DAVE BAXTER
Vice President
Oconee Nuclear Station

May 28, 2008

Subject: Duke Energy Carolinas, LLC
Oconee Nuclear Station, Units 1, 2, and 3
Docket Numbers 50-269, 50-270, and 50-287
License Amendment Request for Reactor Protective System/Engineered
Safeguards Protective System Digital Upgrade, Technical Specification Change
(TSC) Number 2007-09, Supplement 4

Enclosure 1
Duke Response to Remaining NRC Issues

Figure 5-1 – Test Document Workflow and Control Points

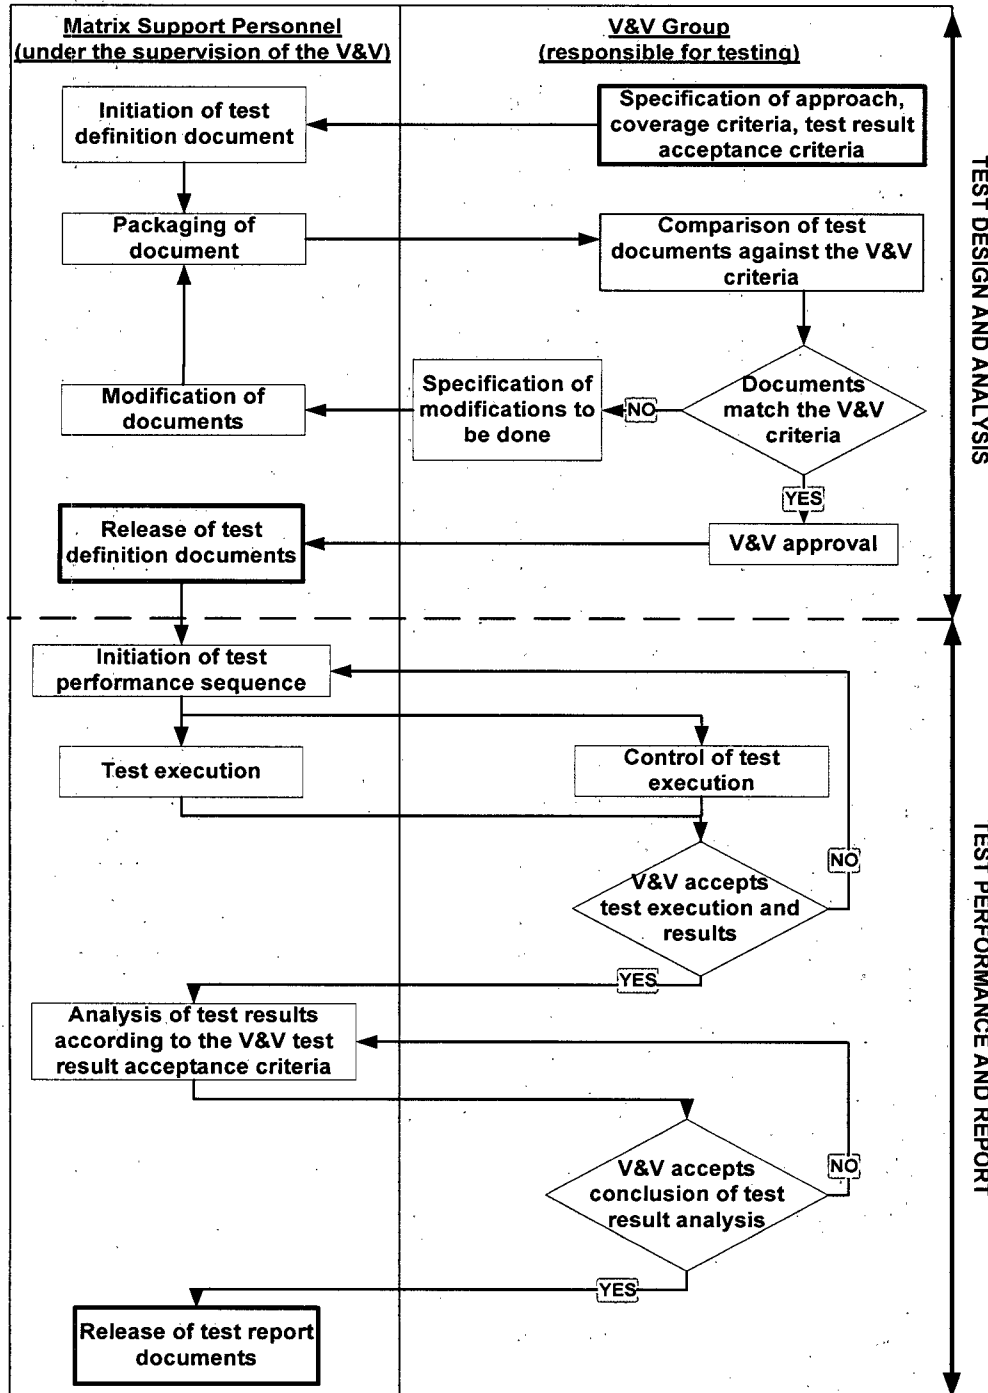
NRC Issue 5: Regulatory Guide 1.168, Revision 1, dated February 2004, endorses IEEE 1012-1998 and IEEE 1028-1997 with the exceptions stated in the Regulatory Position of the regulatory guide describes a method acceptable to the NRC staff for complying with parts of the NRC's regulations for promoting high functional reliability and design quality in software used in safety systems. SRP Table 7-1 and Appendix 7.1-A identify Regulatory Guide 1.168 as SRP Acceptance criteria for reactor trip systems (RTS) and for engineered safety features systems (ESF). The LAR and other associated documents have described certain exceptions to IEEE 1012-1998. In particular, IEEE 1012 makes the generation of various test plans the duty of the V&V organization. The Areva V&V plan, document 51-9010419-005, "Oconee Nuclear Station Unit 1 RPS/ESFAS Controls Upgrade Software Verification and Validation Plan," makes this test plan generation the responsibility of the design or test organizations. The information provided in the LAR and in Areva document 51-9047317-009, "Position Paper: Conformance of TELEPERM XS Application Software with IEEE Std 1012-1998," does not contain sufficient detail to allow the staff to determine the acceptability of this deviation. The staff will require additional information to determine if the proposed alternative to the requirements of IEEE 1012 will provide an equivalent confidence in a high quality test process, and therefore an equivalent confidence in the safety of the resultant system. The additional information to be provided should include that information provided to the licensee for their determination that this alternative to IEEE 1012 was acceptable, and may include the following:

- Documentation of independent V&V Group's Assessment of Testing
- Documentation of V&V Group's Role/Interaction with the Test Group
- Documentation of how Problems identified by the test were Resolved
- Documentation of Duke's Review of the V&V Testing Practices

Response to NRC Issue 5: The details associated with the above issue on Verification and Validation (V&V) were discussed with the NRC during a meeting on April 29, 2008, and during subsequent conference calls on May 5 and 9, 2008. Following these discussions and Duke's review of the ONS RPS/ESPS project V&V activities, Duke and AREVA decided to modify the V&V approach to testing. The following response addresses the changes to the AREVA V&V efforts and will be incorporated into the next revision to the Software Verification and Validation Plan (SVVP).

The revised SVVP will conform to the guidance of the applicable recommendations of IEEE Std 1012-1998, as endorsed by Regulatory Guide 1.168, Revision 1, with one exception related to the V&V responsibilities. This exception is the use of matrixed support personnel from the development groups to assist with some of the validation test activities. The V&V group is responsible for the V&V test development; however, it may get assistance from the Software

Design group, Hardware Design group, and the Test group. The assistance includes the preparation of validation test specifications, procedures, and reports and the performance of test tasks. While assisting with V&V activities, these support personnel work under the supervision of the V&V group. These support personnel may not assist with the preparation of software test documents for design work they prepared. These matrixed personnel bring special skills to supplement the validation activities (i.e. test setup, safety, etc). The test document workflow and control points are shown in Figure 5-1 and ensure that the independence of validation testing is maintained.
